SERVICE BULLETIN

M-1074

Safety Recall Code 092

Detachable Backrest Kits, Part No. 52805-97 and Part No. 52933-97

Figure 1.

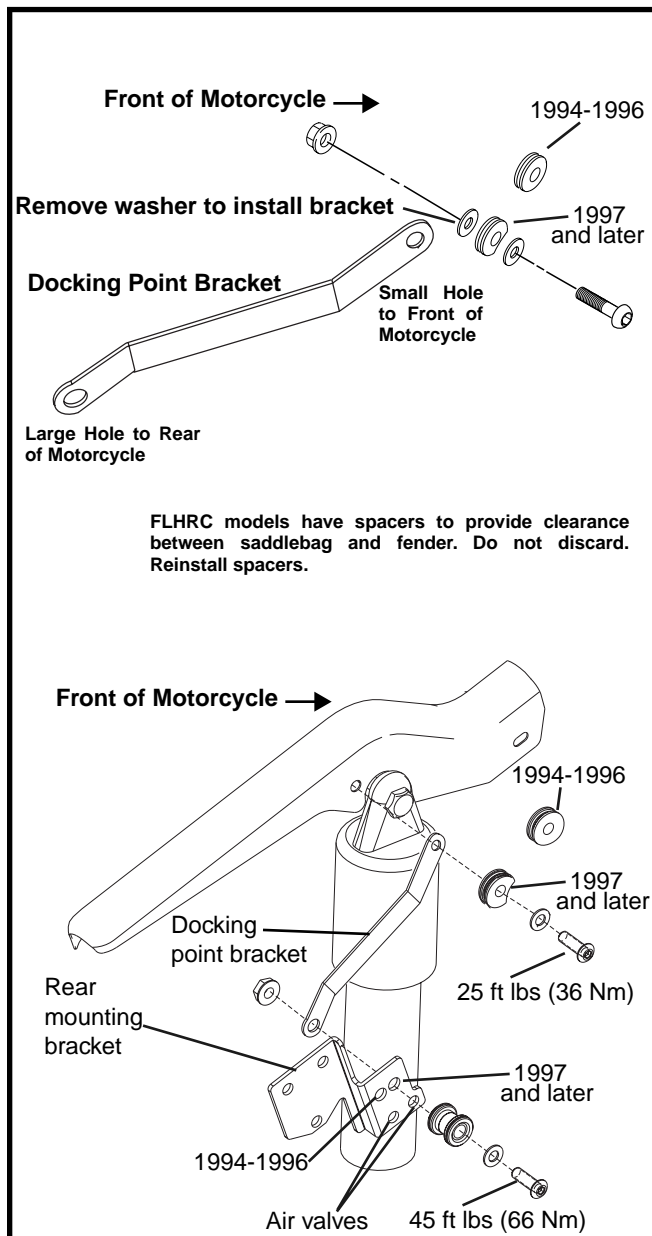
Docking point bracket has a slight bend. Orient bend as shown in Figure 1 with small hole toward front of motorcycle.

4. See Figure 1. Remove rear docking point hardware and position docking point bracket on inside of rear backrest mounting bracket as shown. It may be necessary to loosen fasteners on rear mounting bracket to allow docking point bracket and mounting bracket holes to align.
5. Torque front mounting bolts to 25 ft lbs (36 Nm).
6. Torque rear mounting bolts to 45 ft lbs (66 Nm).
7. If loosened in step 4, retighten mounting bracket bolts.
8. Install saddlebag.
9. Repeat steps 1-8 on other side of motorcycle.
10. See Figure 2 and Figure 3. Install backrest assembly. Confirm full engagement at docking points.

3. Discard inner flatwasher and install docking point bracket (small hole end) in its place. Do not torque at this time.
